Change Order #7 Dicker Road

Project: Dicker Road
Project #: STP 1902 (383) MM
Contract: C-19-017-11-05
CSJ: 0921-02-312
Limits: Spur 115 (23rd Street) to FM 2061 (Jackson Road)

Change Order #7 has been approved to make the following contract changes:

FED. RD DIST. NO.	CONTRACT	SECTION	JOB NO.	HIGHWAY	
06	0921	02	312	DICKER ROAD	
STATE	DIST	COUNTY	PCT	CITY	SHEET NO.
TEXAS	PHR	HIDALGO	No 2	HIDALGO	157a

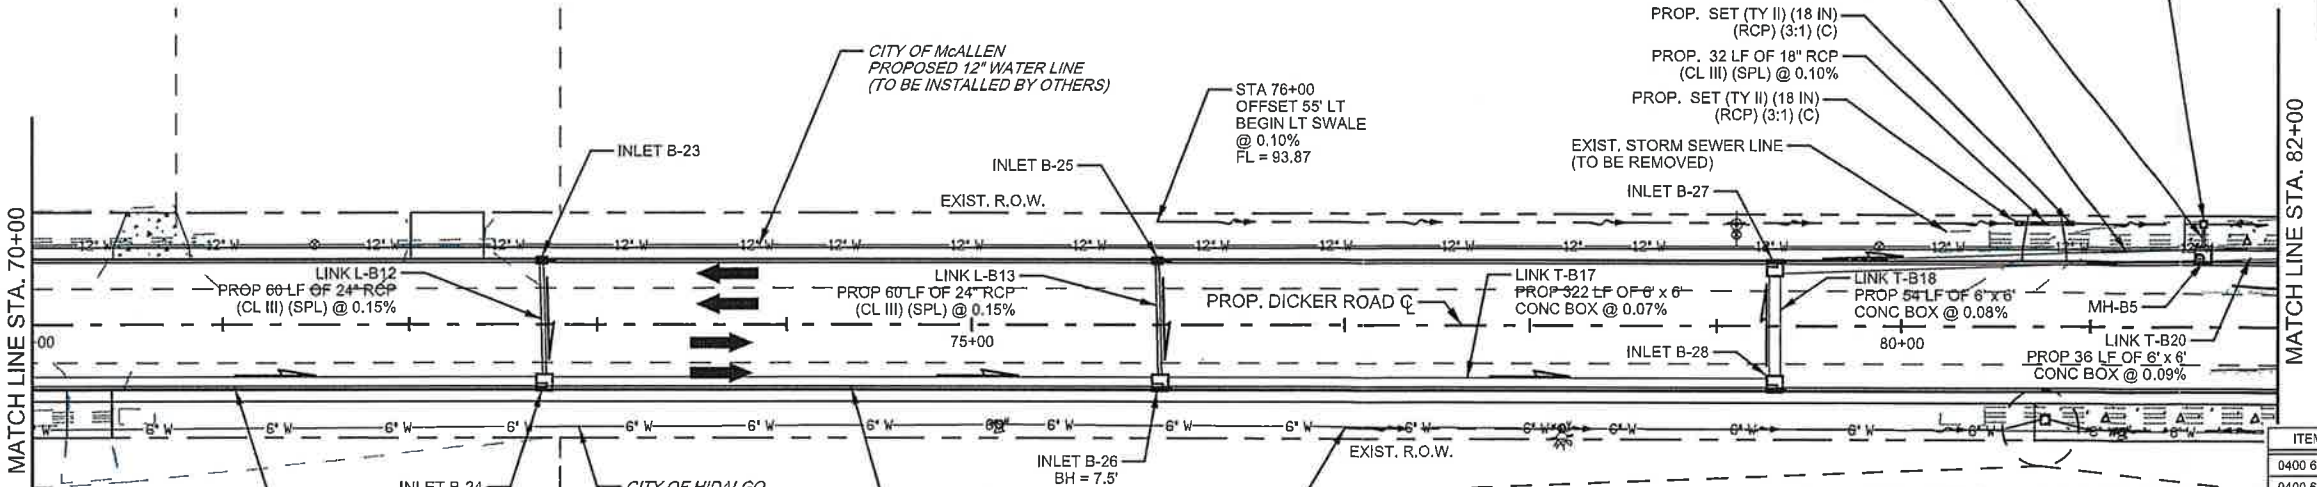
CO #7 - Change Order #7
Adjust the 6x5RCB plan quantities to match field conditions

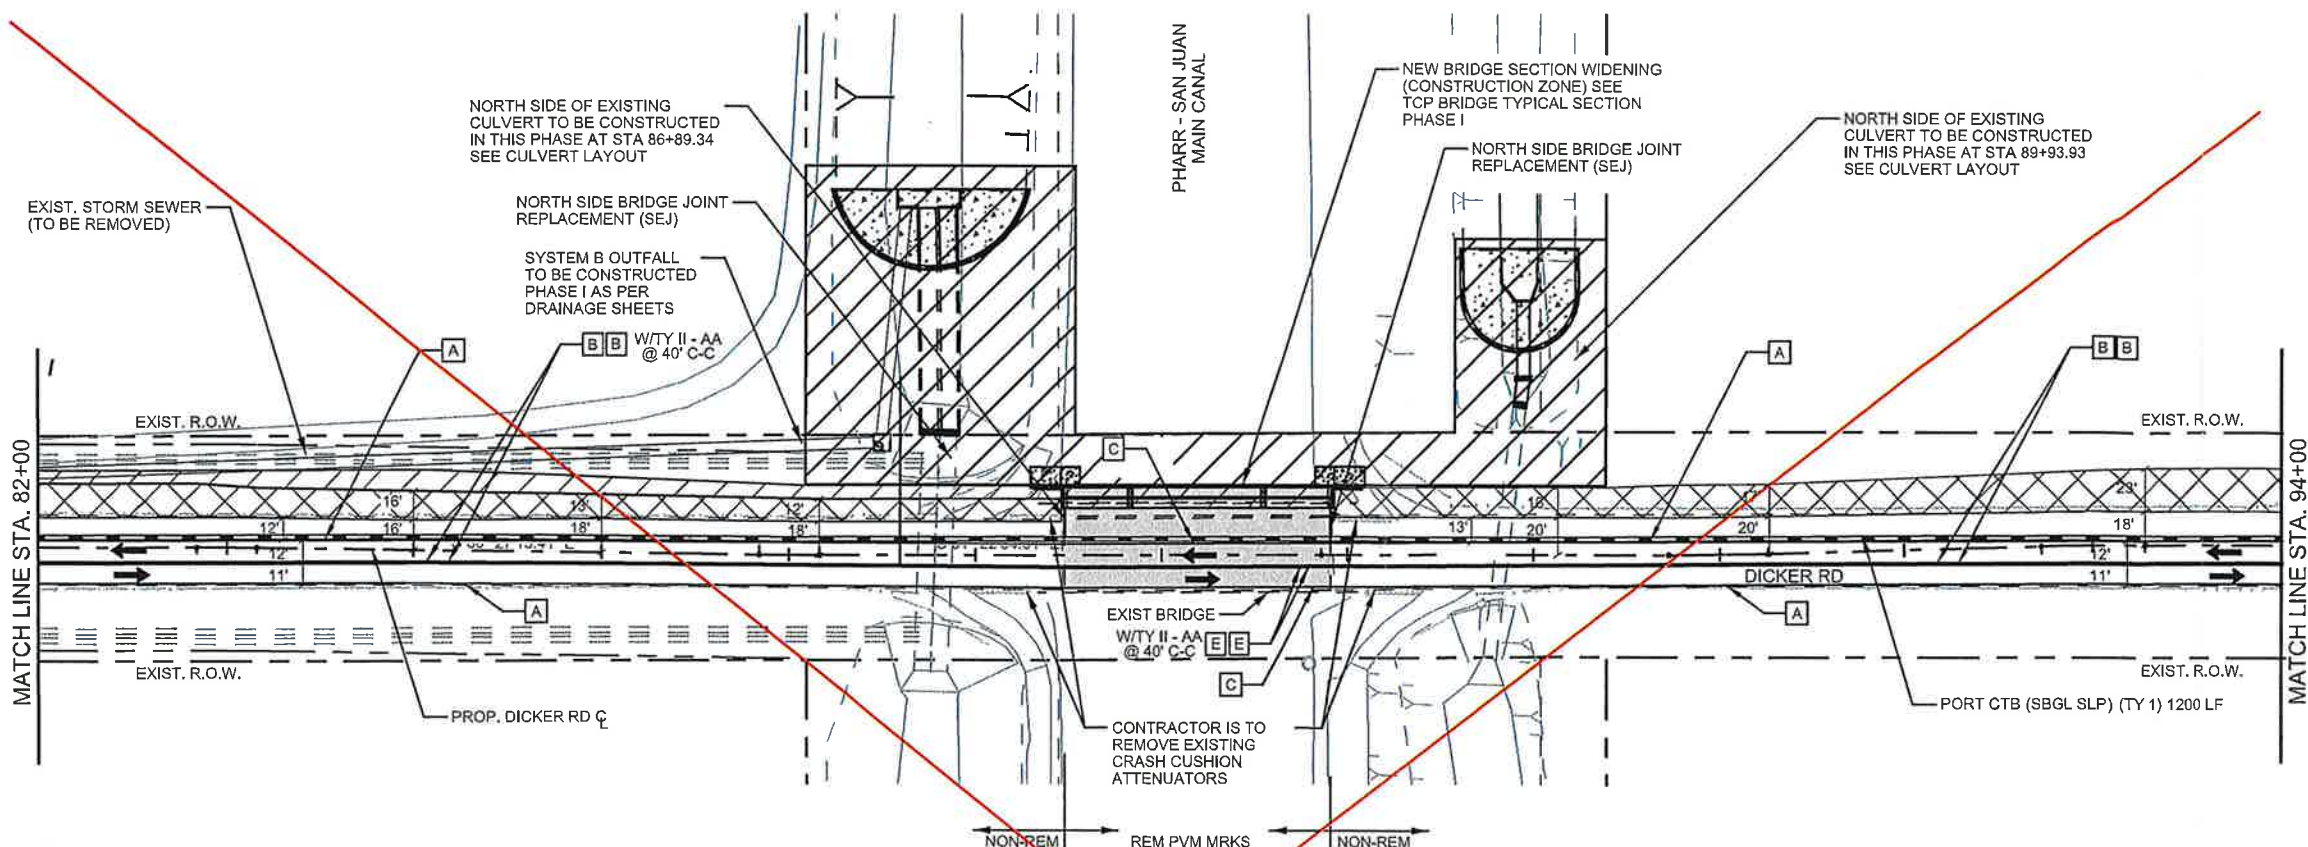
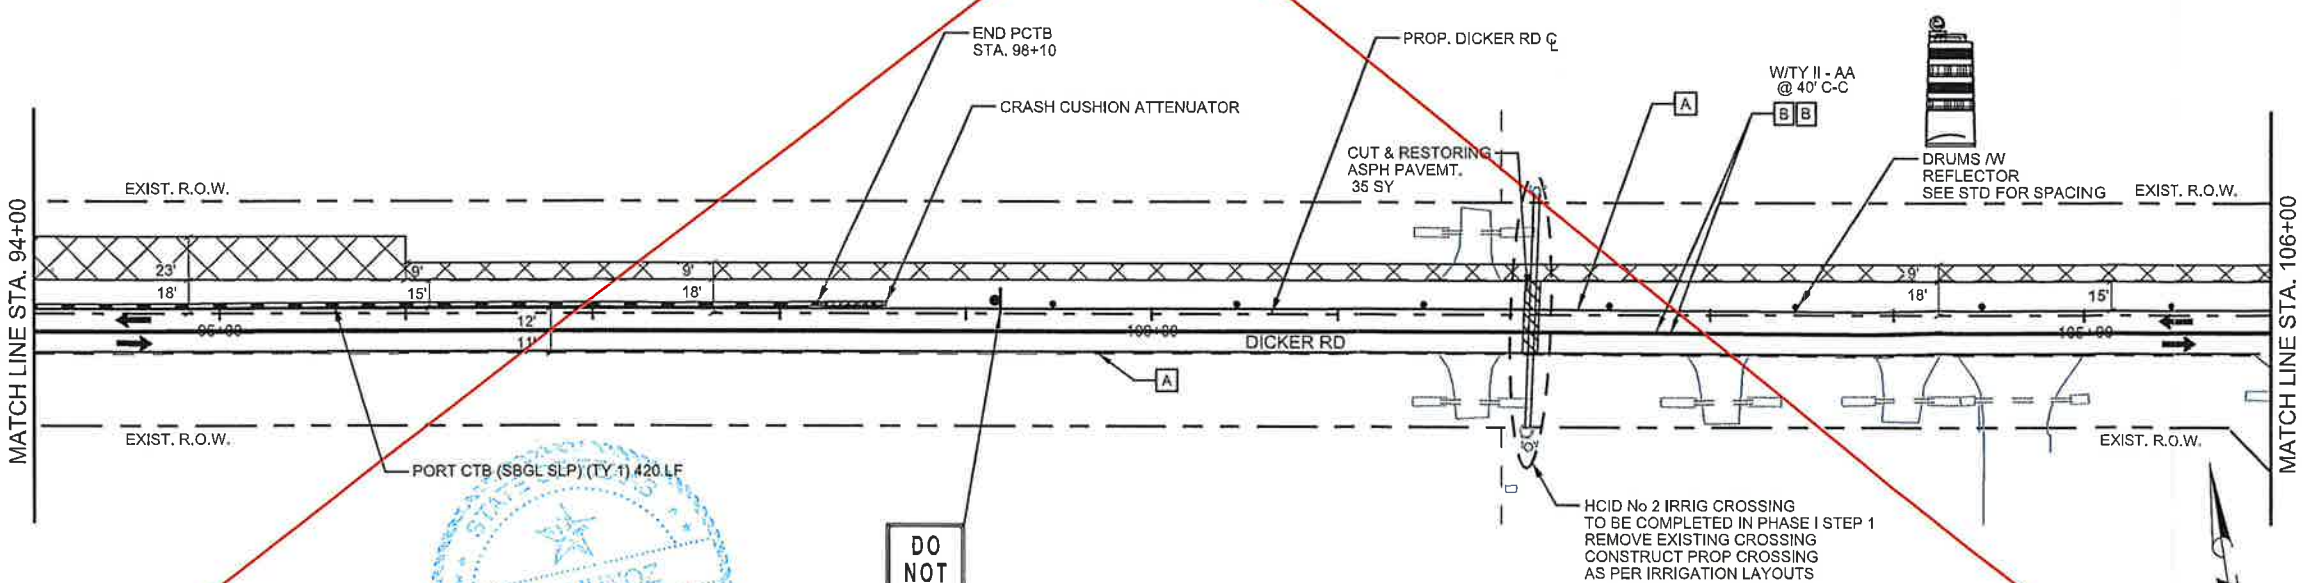
CO #7 - Detour Traffic
Close Dicker between 10th Street to McColl Road

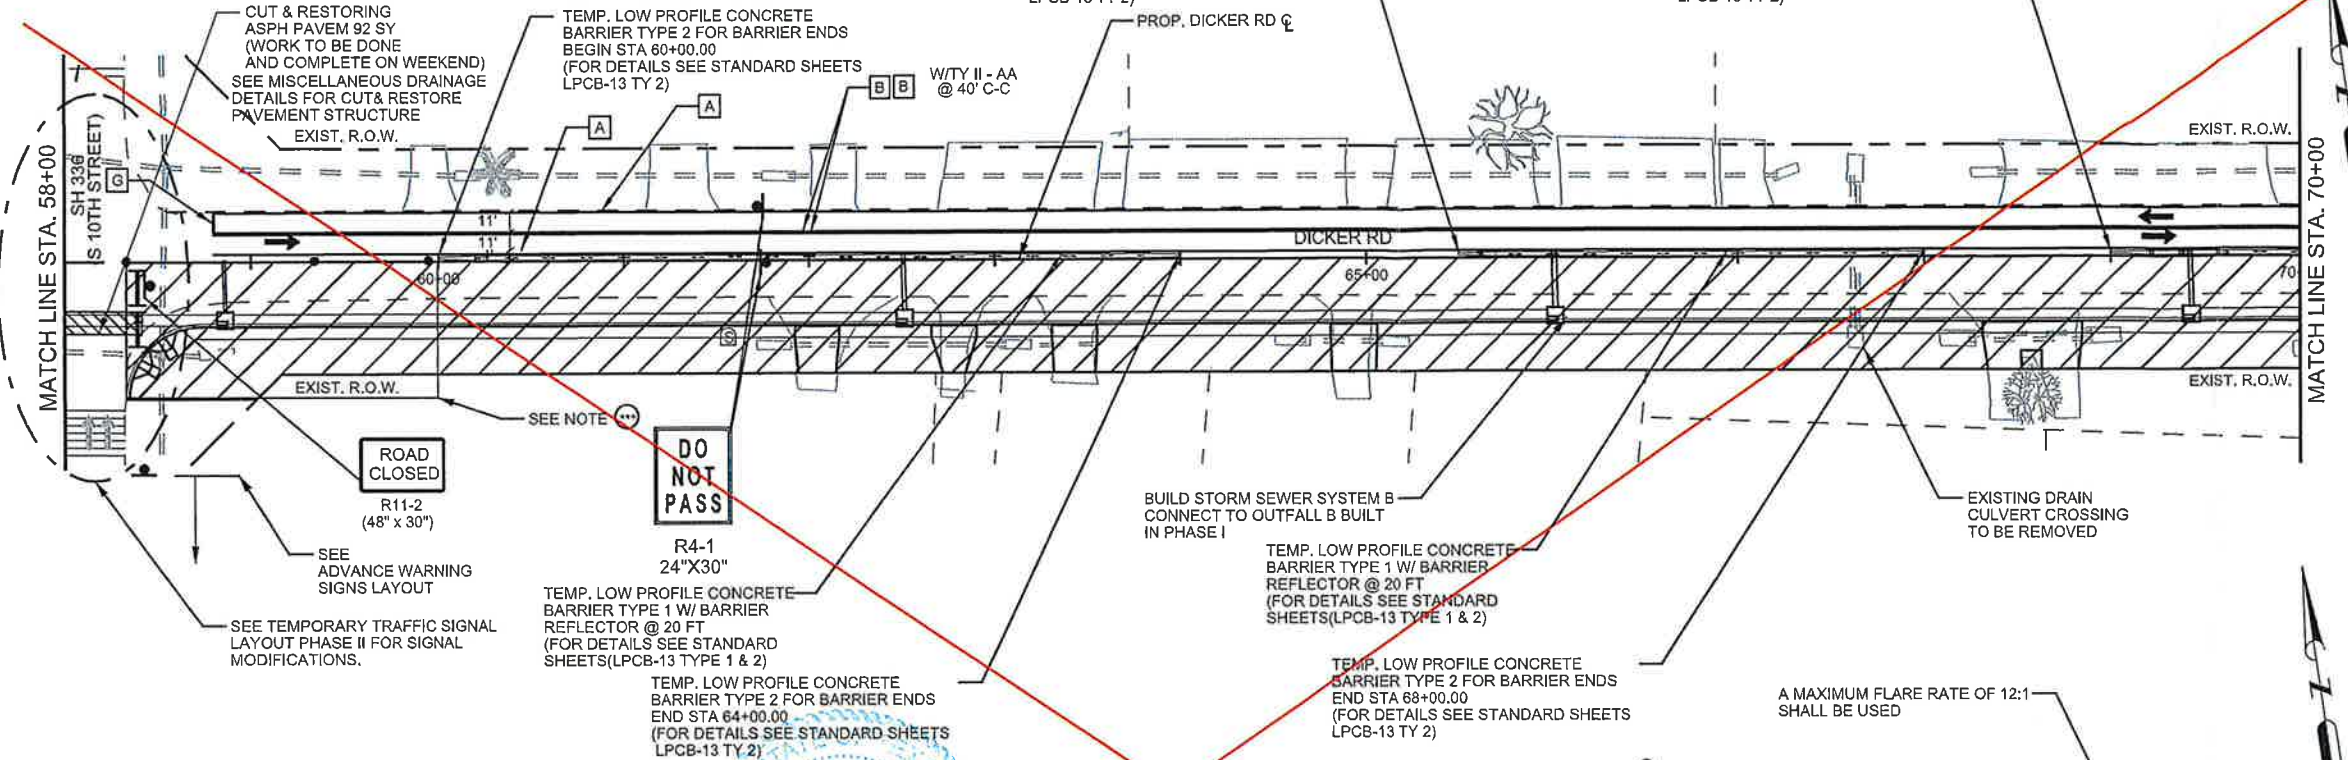
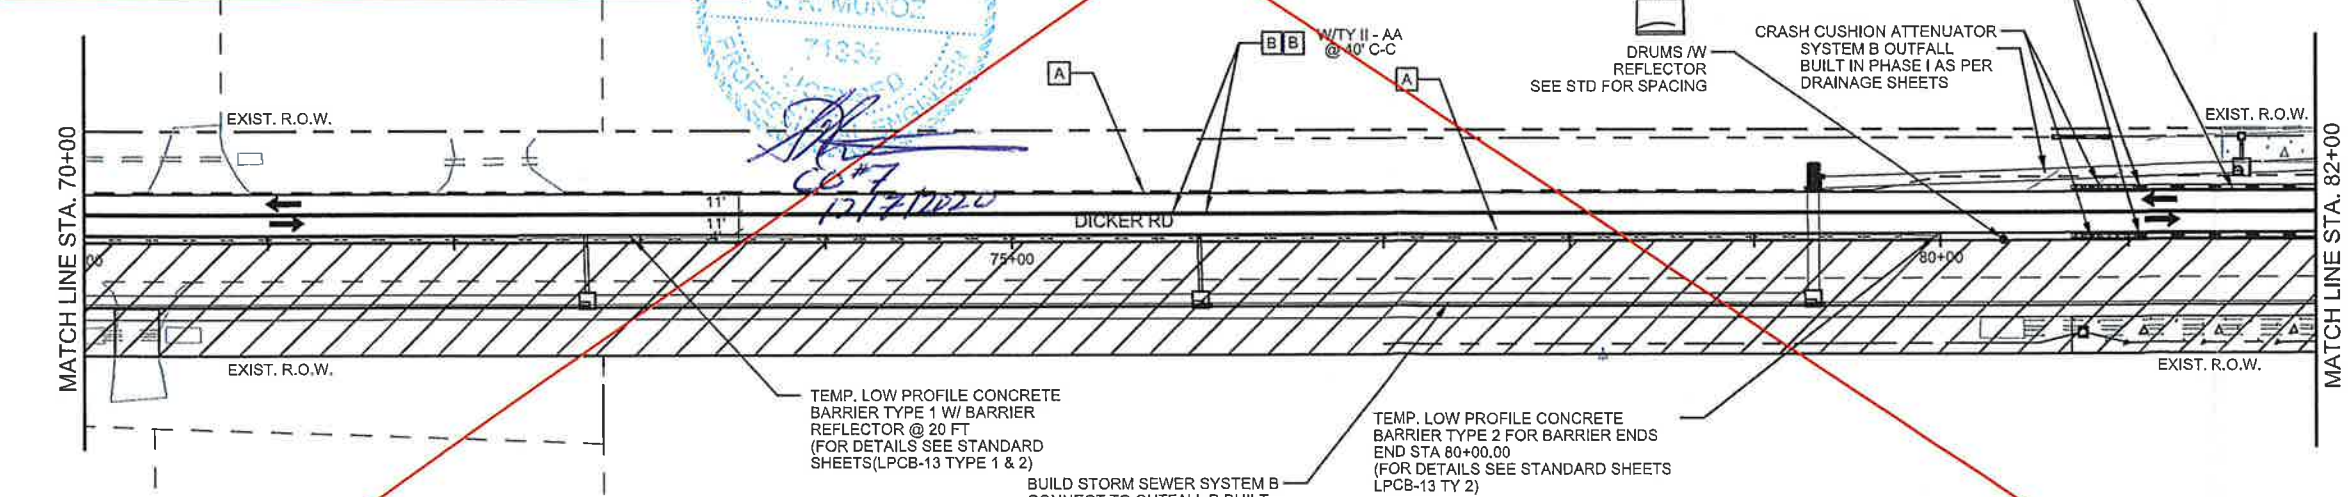
CO #7 - Detour Traffic
Close Dicker between 10th Street to McColl Road

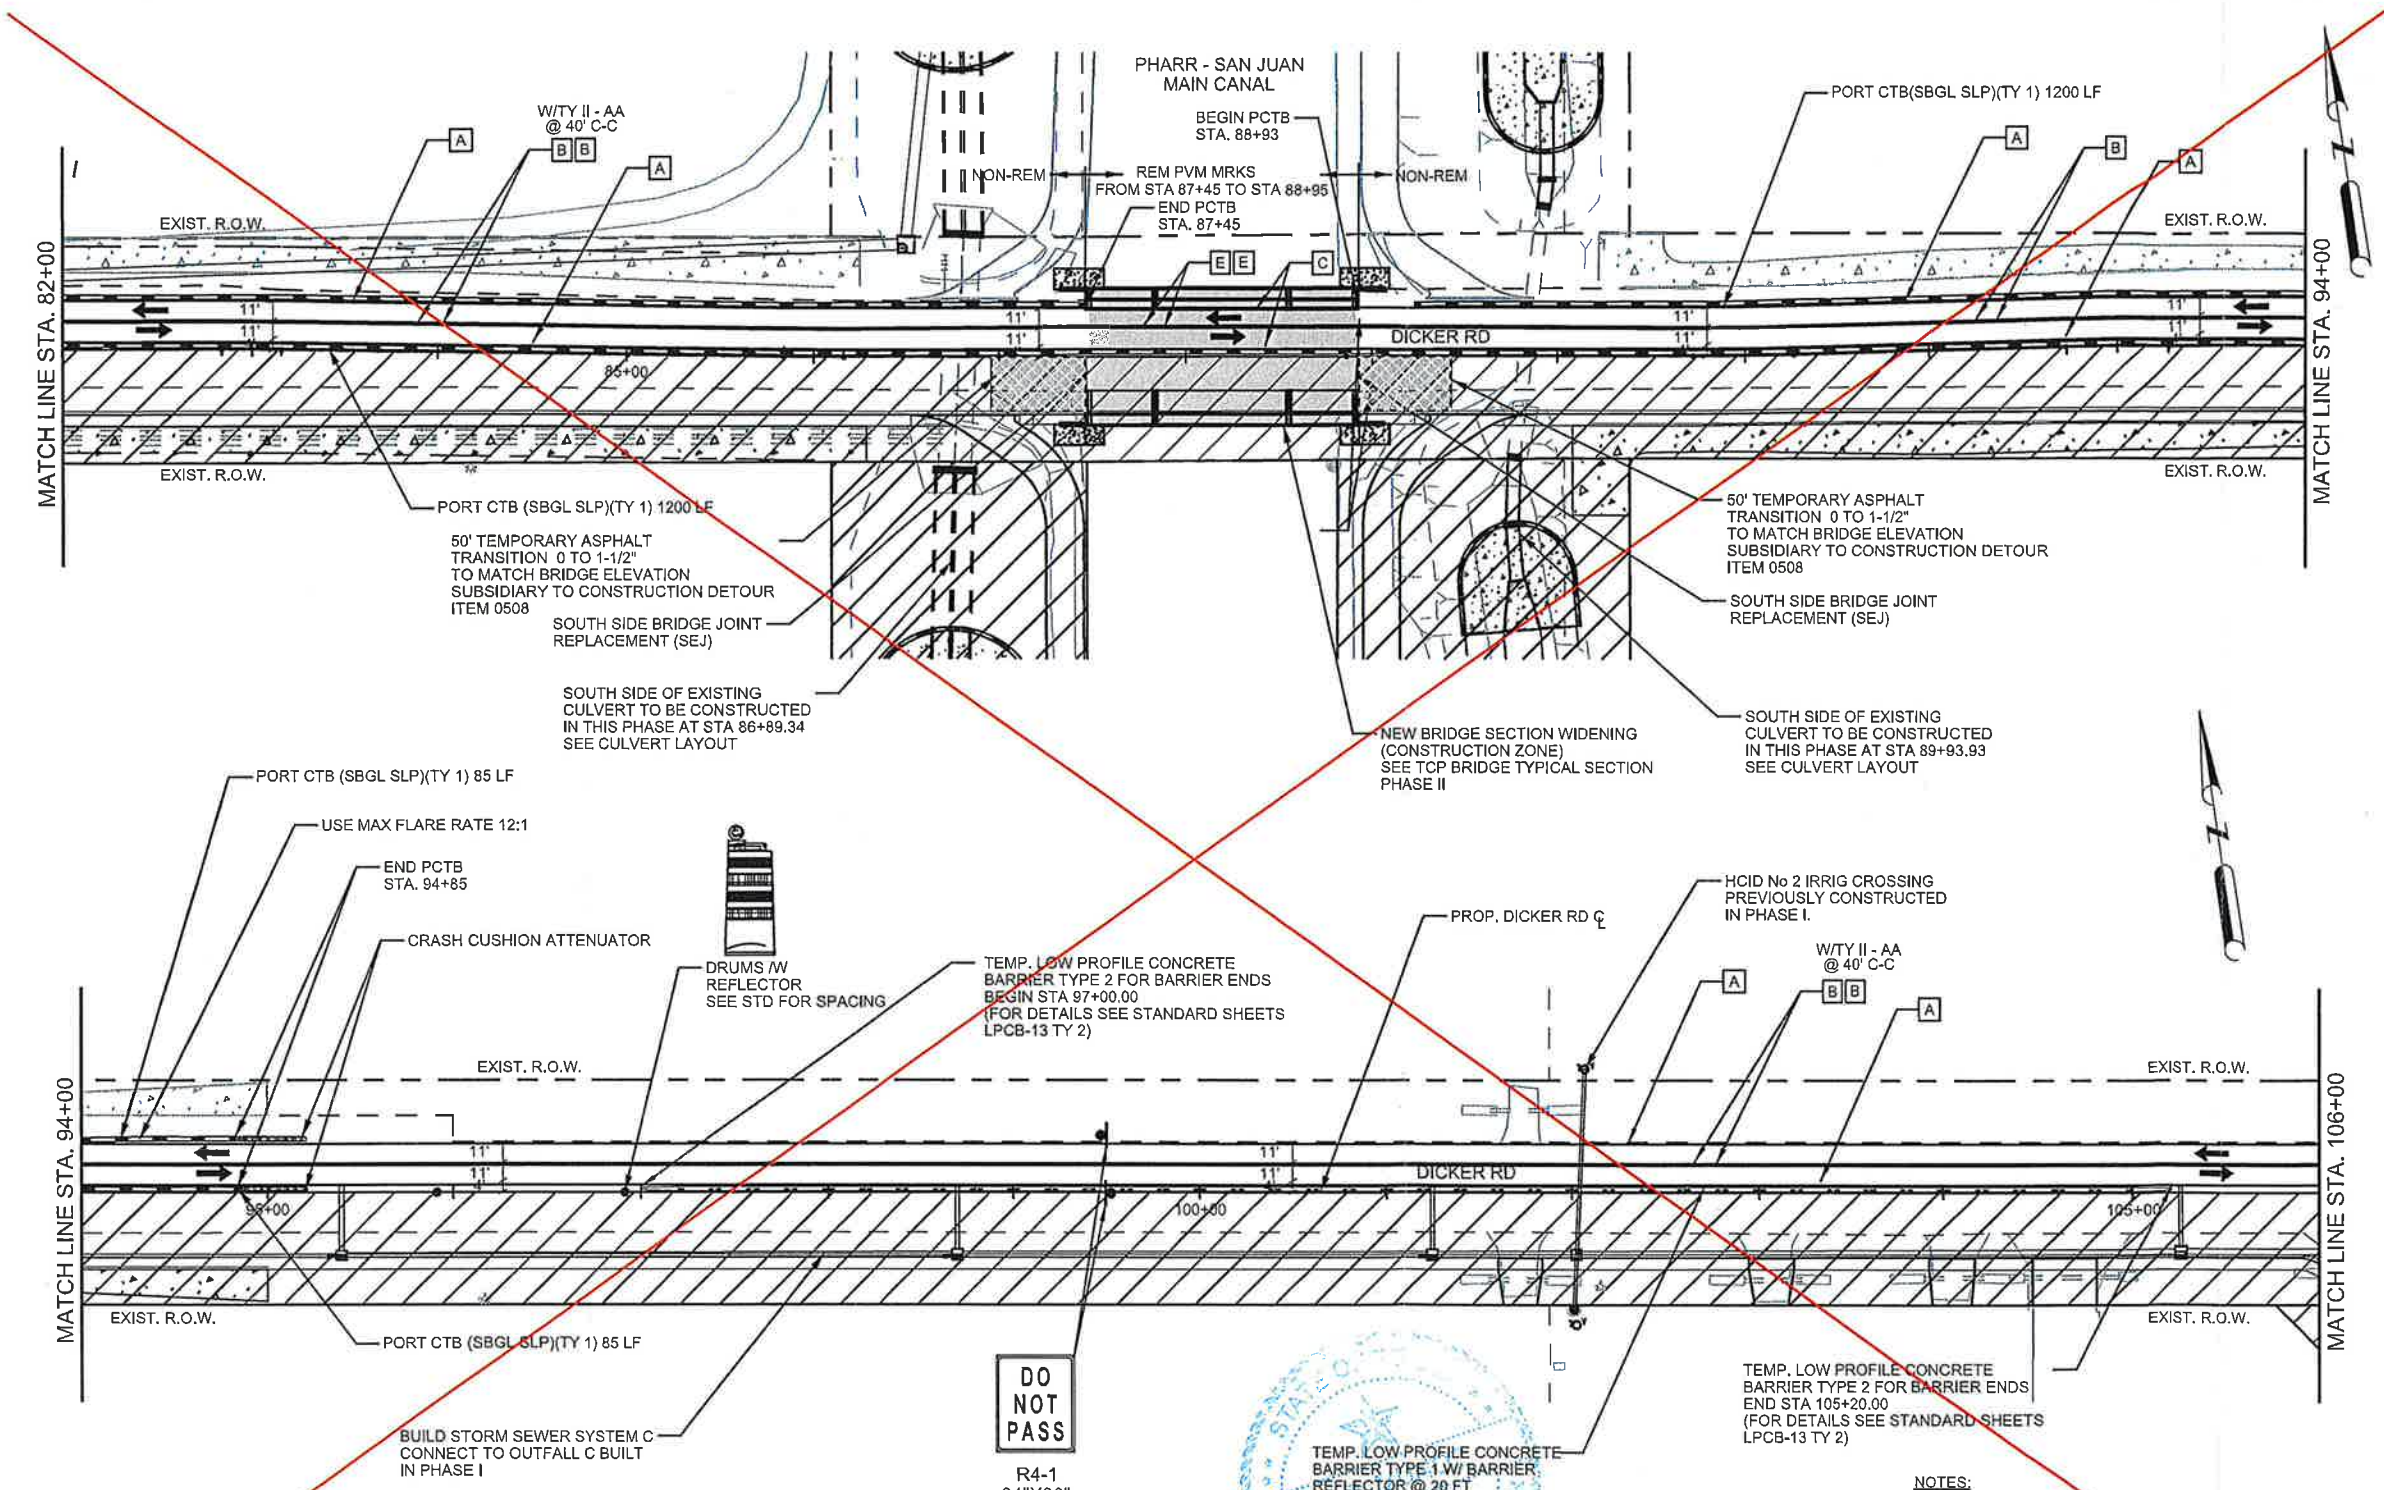
CO #7 - Detour Traffic
Close Dicker between 10th Street to McColl Road
